ADDENDUM

NO. 1

PROJECT NAME: Tomball ISD Intermediate School Replacement

ADDENDUM DATE: Tuesday, July 28, 2026

1 MECHANICAL PLAN - LEVEL 01 - AREA C
M2.1C 1/8" = 1'-0"

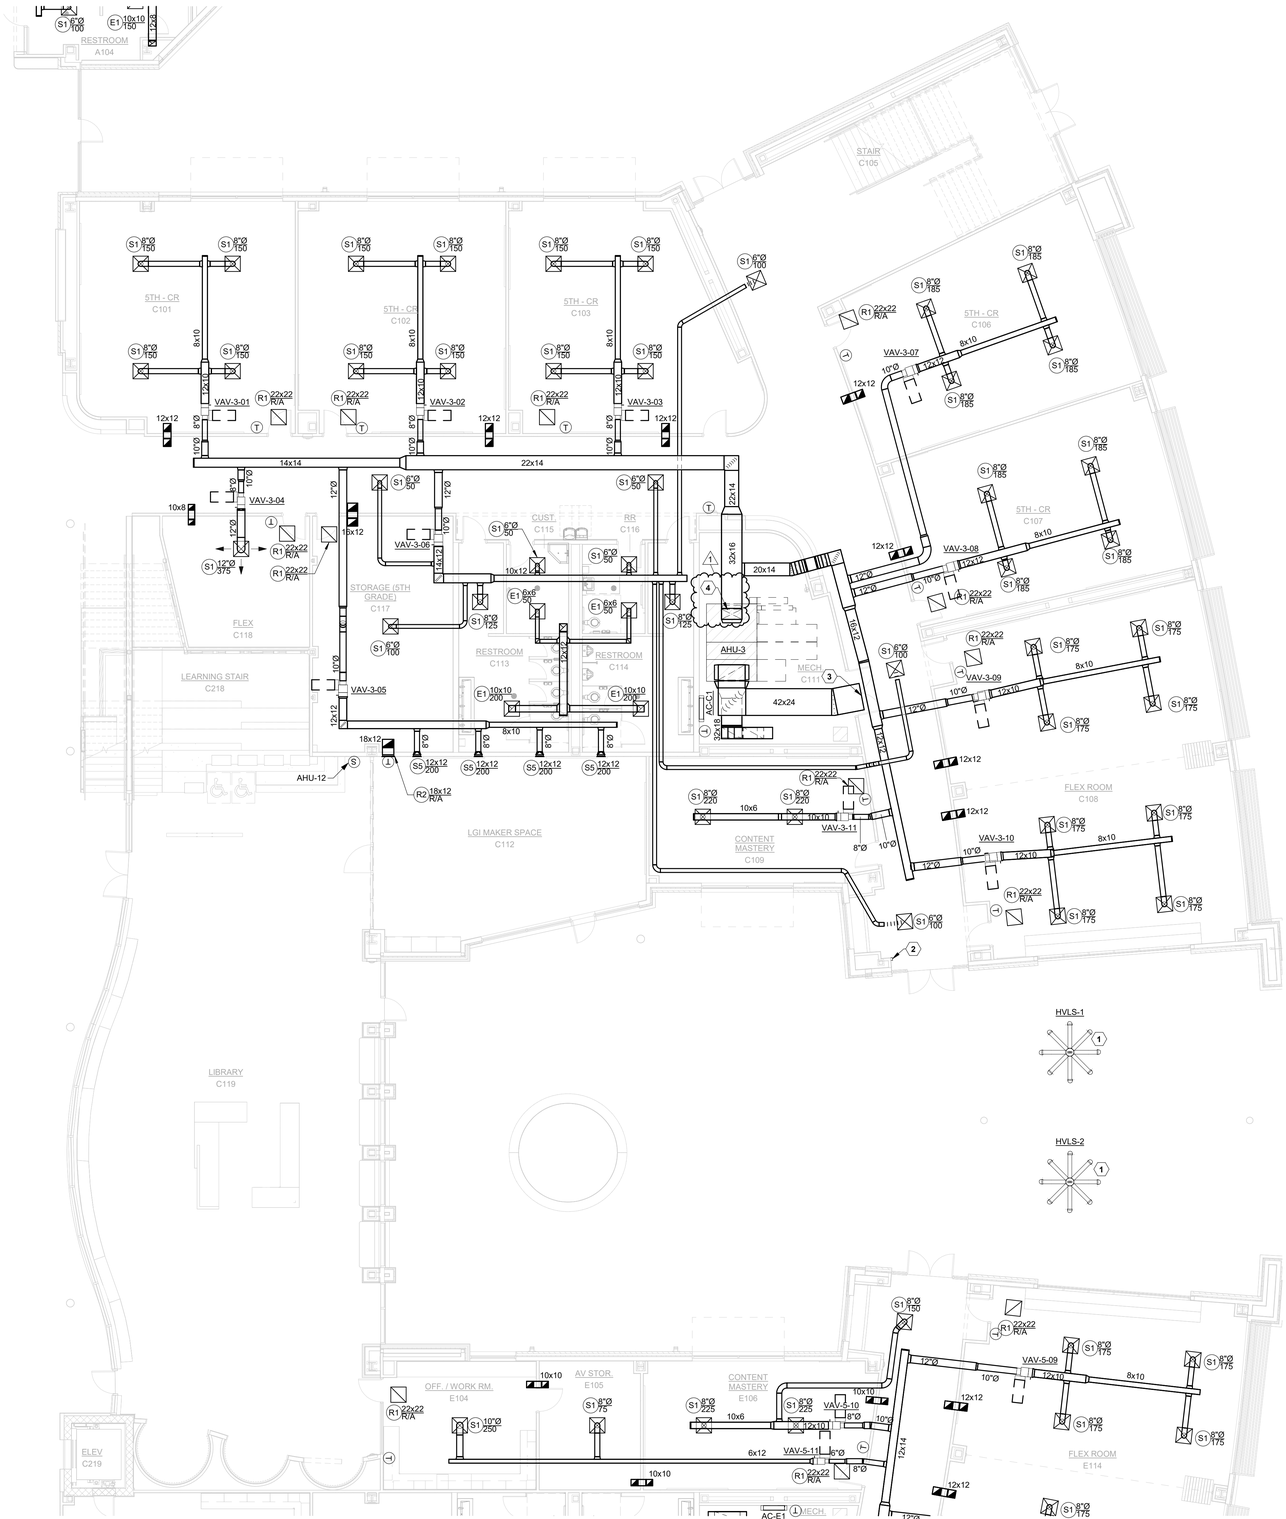
AD No 1, Mech. Item 2: To the Drawings, Sheet M2.1C, "MECHANICAL PLAN – LEVEL 1 – AREA C"

1 E1.00 ELECTRICAL POWER SITE PLAN
1" = 30'-0"

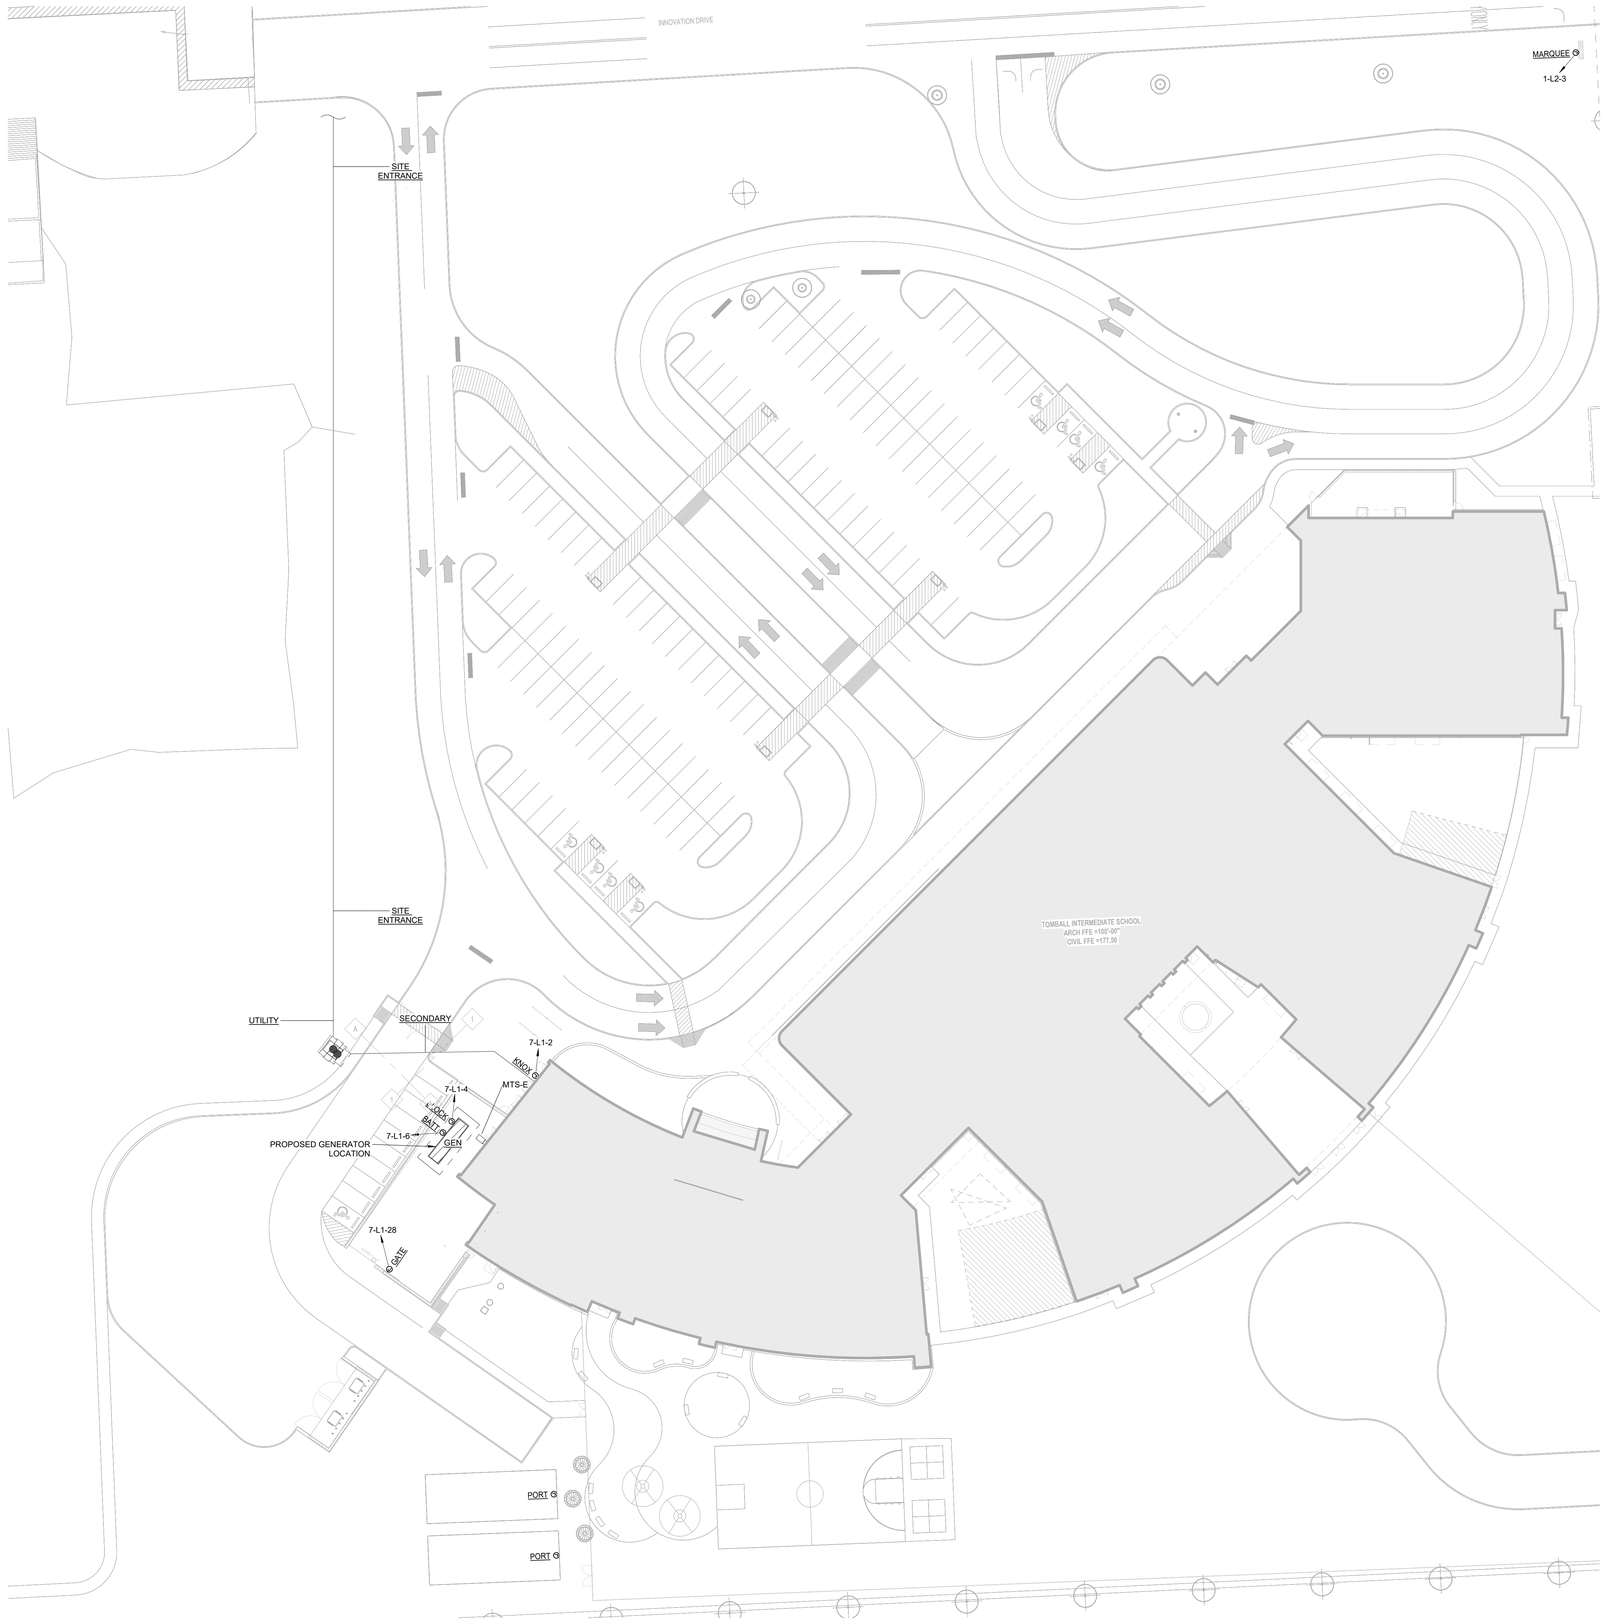
AD No 1, Elec. Item 2: To the Drawings, Sheet E1.00, "ELECTRICAL POWER SITE PLAN"

3 STAGE FACING TRANSVERSE ELEVATION
1/4" = 1'-0"

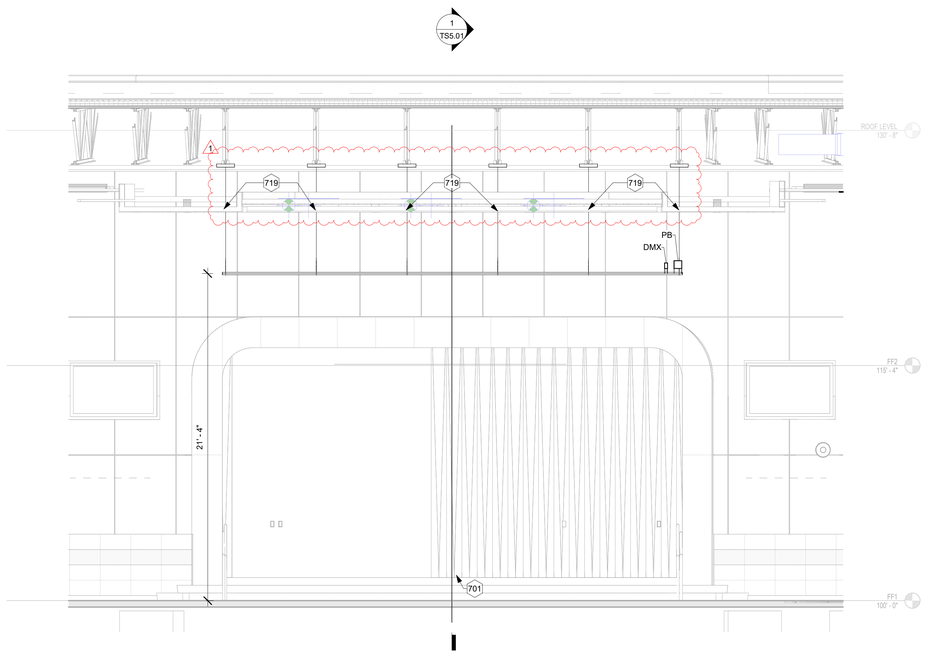
AD No 1, AV/TS. Item 6: **TS5.01 – SECTIONS AND RIGGING SCHEDULES**
- Revised Lineset Schedule – Dimensions From Datum, Lineset 4 Offset
- Revised Drapery Schedule, US Traveler with Rear Liner Size, Main Drape Size
- Clarified Keynotes 719 and 718 on Detail 2, "FOH FACING TRANSVERSE SECTION"
- Revised Lineset 4 Offset; Clarified Keynotes 719 and added Keynote 722. Updated Lineset 1 Drapery Height on Detail 1, "PLATFORM CENTERLINE SECTION"
- Added instances of Keynote 719 on Detail 3 "STAGE FACING TRANSVERSE ELEVATION"
